8.2 Architectural Response to SDRP 01 Comments

State Design Review Panel - Review 1 - Comment	Architectural Response
1. Expand the consultation process and its scope to better understand perspectives of female students. Focus on the nuances of how girls use and share different spaces, and their needs and behaviours.	Extensive consultation was undertaken with Newington College, including with Newington's Director of Co-education. At the concept proposal level for the masterplan, it was established that the Centenary Hall conversion to the central cafeteria space represented a positive approach to welcoming the new student cohort, in this legacy building for the college with a prime position on Memorial Drive, the opportunity to deliver a purpose designed gathering space for all is seen as a key requirement for the success of the shift to co-education. At a detailed level, for the Sevington Courts building, care has been applied to the layout of Level 1 in particular to create a sense of openness throughout the floorplate, with good lines of vision and a clear separation between the teaching and learning spaces and the strength and conditioning centre. Both gender specific and uni-s

Relationship to Stanmore Road

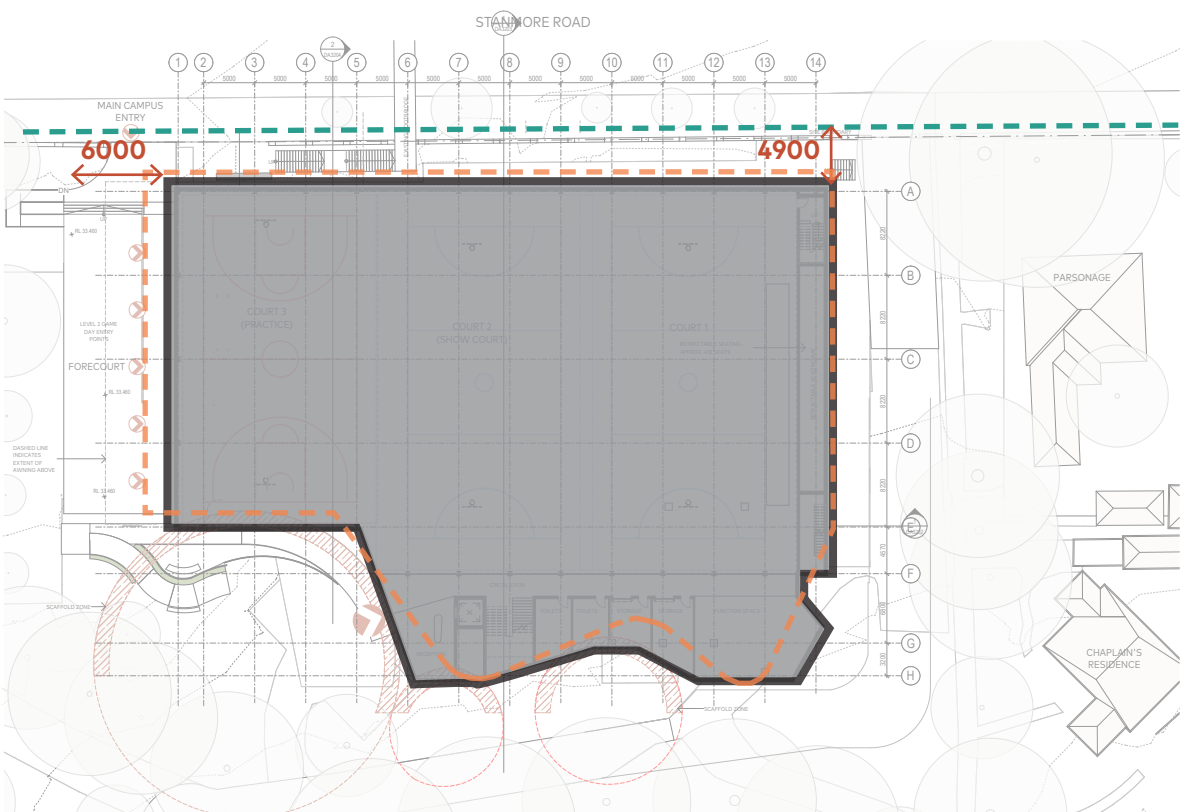
8. Review the relationship between the Sevington Courts building and the retained trees along Stanmore Road and the heritage fence/entry gate, to ensure the amenity of the streetscape is maintained and improved. a. increase the setback at Stanmore Road to avoid the building 'crowding out' the streetscape and trees along the fence line b. increase the western setback to the entry gate and sandstone wall.	Following the feedback from SDRP Review 1, measures were taken to rework the design to achieve the requested set-backs from Stanmore Road and the west. A summary of the amendments are illustrated below, the resulting alignment on Stanmore Road in particular provides a buffer to the conifers and the streetscape in general.

Previous Building Footprint at SDRP #1

Revised Building Footprint at SDRP #2

Western entry to sports courts

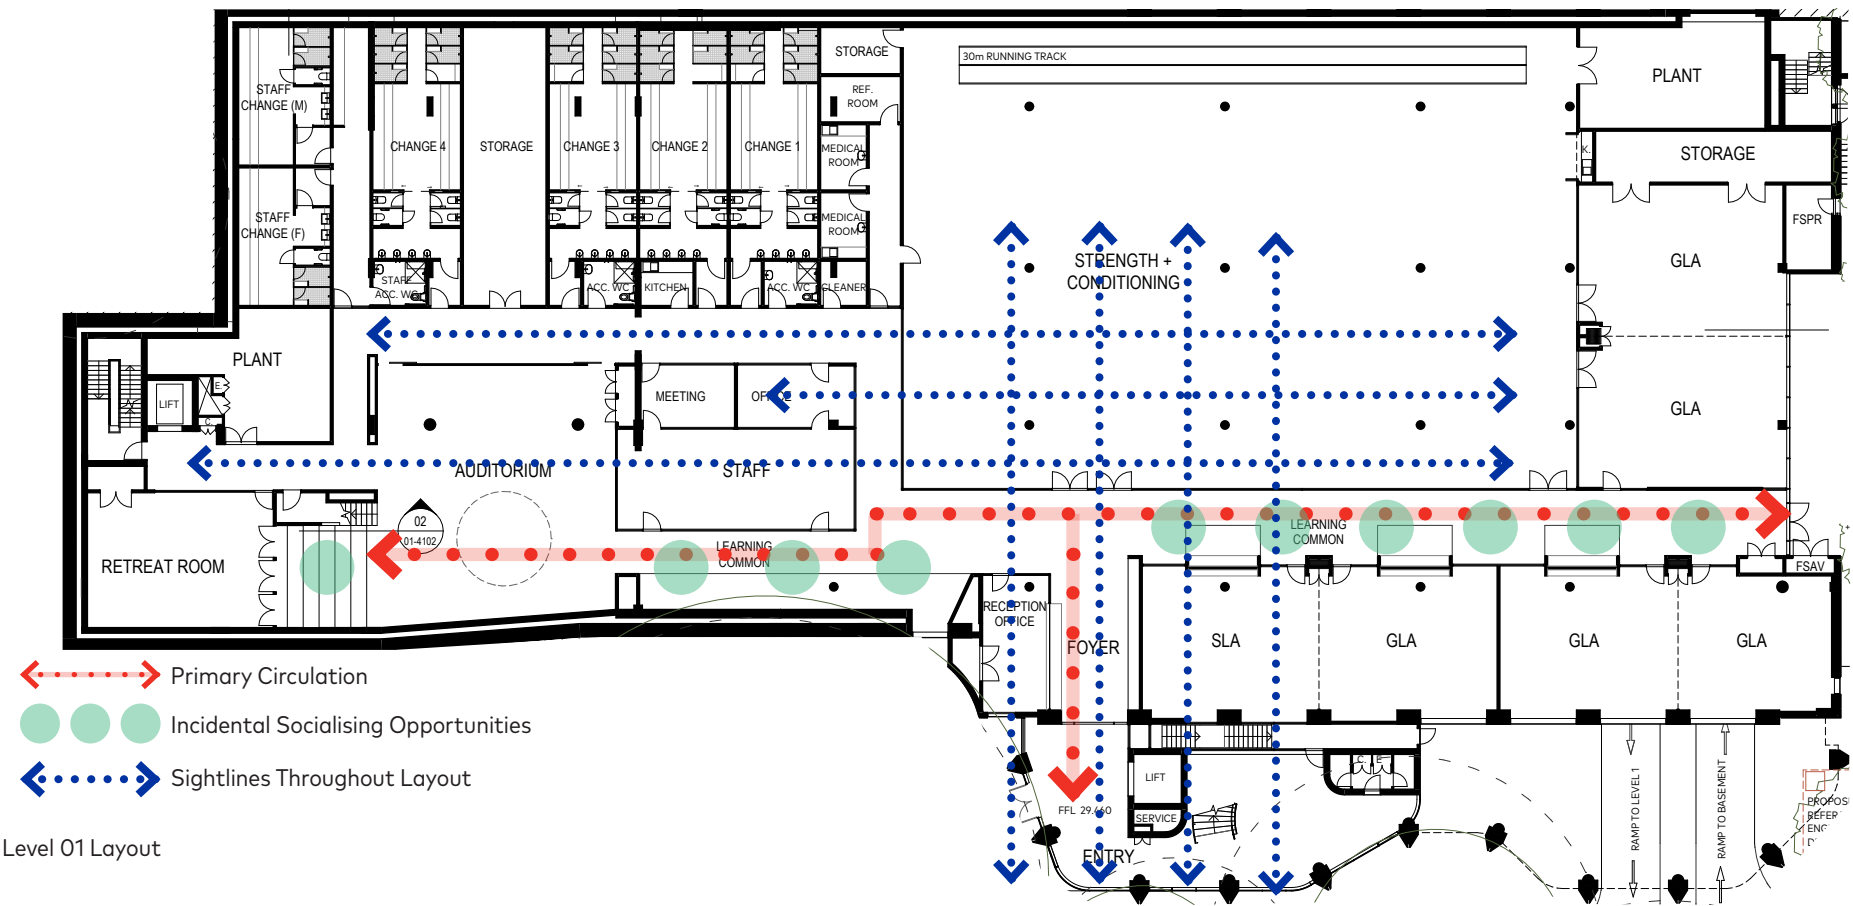
15. Demonstrate how each facade responds to the master plan, streetscape and site conditions to of its orientation, including:

- a. breaking down the visual bulk and scale
 - b. fenestration that to promotes activation and daylighting, while balancing the need for privacy with the intent for views.
16. At all entrances and forecourts improve the arrival sequence and sense of address. Explore scale transitions and define clear entries with welcoming elements (e.g. awnings).
17. At Level 1 (The Fitness Centre), refine the layout of corridors and vertical transition spaces to create clear circulation paths and sightlines and promote incidental socialising.

A full description of the treatment of each facade and how it relates to its wider site context and function can be found on the preceding pages of this report. The Stamore Road facades are articulated to provide a mix of openness to engage with the community space and more opaque configurations to help deal with glare and noise for the sports hall in particular. East and west facades of both buildings are generally read as more opaque to reduce solar gain where low-sun angles adversely impact the facade, where glazing has been incorporated, these are generally treated with vertical sunshading to reduce the impact of solar ingress. The south facades are treated with large areas of glazing to engage with the campus itself and, in the case of the sports-court wing, to engage with the tree canopies that are located immediately adjacent.

Described at item 5 and 14, the forecourt helps address the sense of arrival from Stanmore Road. Within the forecourt, the Pavilion facade has been recessed and glazed, both providing an awning created by the floors above, and a space that is visually interconnected with the forecourt. To the western facade of the sports-hall, a recessed and glazed entrance has been provided, with awnings sitting above the door line. The southern facade of the sports hall is framed with large GFRC column and slab covers, or cladding, which help to provide definition to this predominately glazed facade, the expression of the circular stair on the facade by extending the glazing up above the top habitable floor, helps indicate the entrance to Sevington from a distance (ie across Johnson Oval and from the Founders building).
